H SALES ENGINEERING UPDATE

NO: SEU-9802

SUBJECT: HN-402/462 Auxiliary Spring Assembly

EFFECTIVE DATE: August 1998 REVISION: A

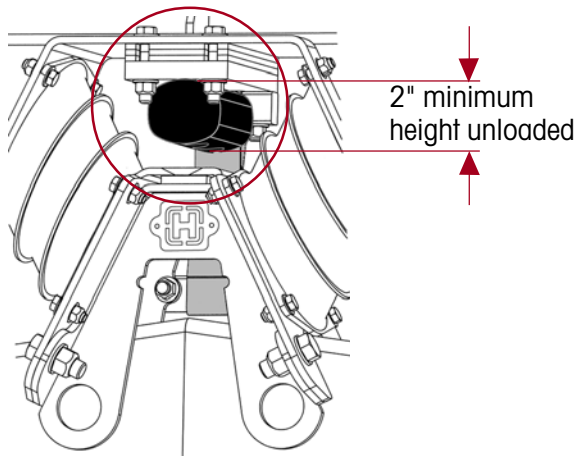
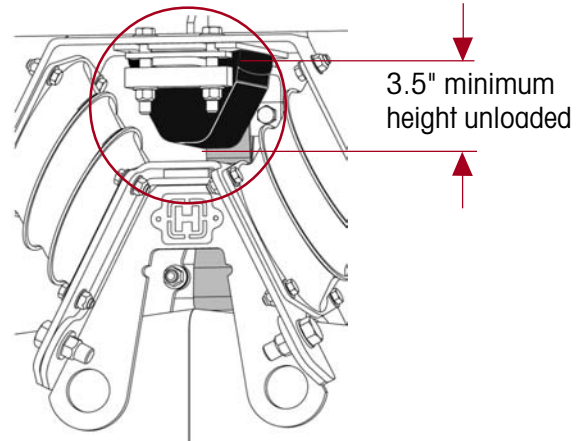
DISCONTINUED Auxiliary Spring Assembly 58189-000

NEW Auxiliary Spring Assembly 58947-000

Effective August 1998, Hendrickson replaced the auxiliary spring assembly in production for the HN-402/462. The new auxiliary spring maintains a higher level of performance and durability in severe applications and is completely interchangeable with the discontinued auxiliary spring assembly. The discontinued auxiliary spring assemblies are obsolete and no longer available, see list below for the new auxiliary spring assembly kits.

Periodic inspection of the auxiliary spring is required. Replacement is needed if the unloaded height of the auxiliary spring is less than the minimum as shown in the views above. It is recommended that both sides of the tandem are replaced with the new auxiliary spring to operate properly. For HN-402/462 auxiliary spring replacement instructions, see Technical Publication 17730-227.

Service Kit to replace discontinued auxiliary spring:	(part no. 58189-000)	57974-011
Service Kit to replace new auxiliary spring:	(part no. 58947-000)	57974-012
